From: Laurel Christian <LChristian@cityofsalem.net>
Sent: Thursday, August 1, 2024 1:40 PM
To: Shelby Guizar
Subject: RE: Vision Clearance along Alleys

Laurel, apologies, the vision clearance triangle I am referring to is the intersection of Grove St and the alley for the Voyager Village development. They are extending the alley on their private property per your request in the pre-ap, and I think they are measuring the triangle appropriately, except with how wide the ROW is along Grove, a vision clearance triangle where they are showing it doesn't make sense since it is still quite a way back from the intersection. They are trying to see if they can place the transformer in red in that location shown below. Should I pass this to Tony to see where he would identify the triangles for this site? Thanks for your help!

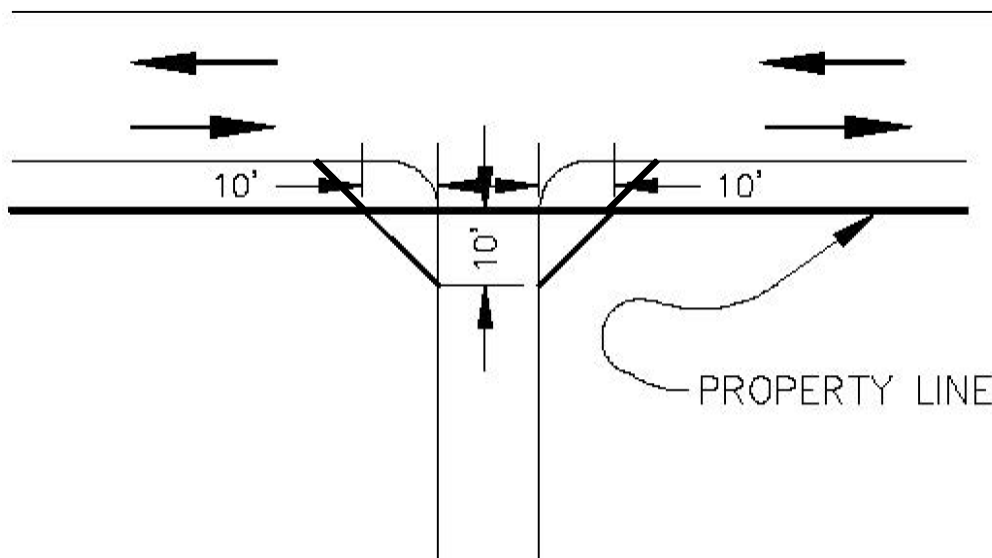
I can't tell if they are measuring it from the centerline of the alley or the property line abutting the alley? It does not look like the vision clearance is drawn quite right per SRC 803.005(b)(3) FIGURE 805-8. ALLEYS (see below). The vision clearance should be measured from the centerline of the alley and not the property line. I can't quite tell from the plans where it's being measured from. The sidewalks along Grove should be moved to the property line. When it's drawn like that it makes more sense why the vision clearance is measured at the property line as it reduced vehicle/ped conflicts.
